UNITED STATES
NUCLEAR REGULATORY COMMISSION
WASHINGTON, D. C. 20555

REVIEW OF GENERAL ELECTRIC TOPICAL REPORT NEDE-2094-P (TAR-1270)

Report Number: NEDE-2094-P
Report Title: Safety Relief Valve Discharge Analytical Model
Responsible Branch: LWR 1-2
DRL Program Manager: E. Butcher
Requested Completion Date: N/S
Review Status: Incomplete

REQUEST FOR ADDITIONAL INFORMATION

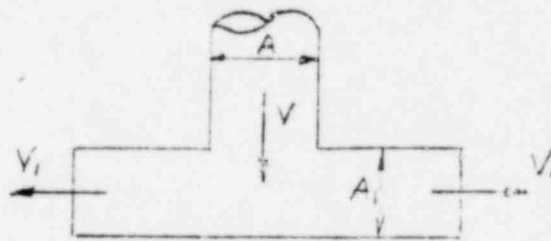
10. Identify which test of the Quad Cities' tests has been used for Figure 11.
11. On Page 50, Appendix B, it is stated that "the flow is sonic at both sections. . . .", while it is also stated on Page 11, Section 3.14 that "After the water plug is expelled, the air leaves the pipe at sonic velocity." The inconsistency of these two statements ~~could~~ *is illustrated by the following* be easily explained by the following graph:

Appendix B specifies that the velocity V_1 is sonic, while Section 3.14 says V is sonic. Since A_1 is equal to A and flow rate passing A_1 is equal to one-half of that flowing through Section A , the velocity V_1 should be one-half of the velocity V . Explain this discrepancy and reanalyze the pool response if necessary.
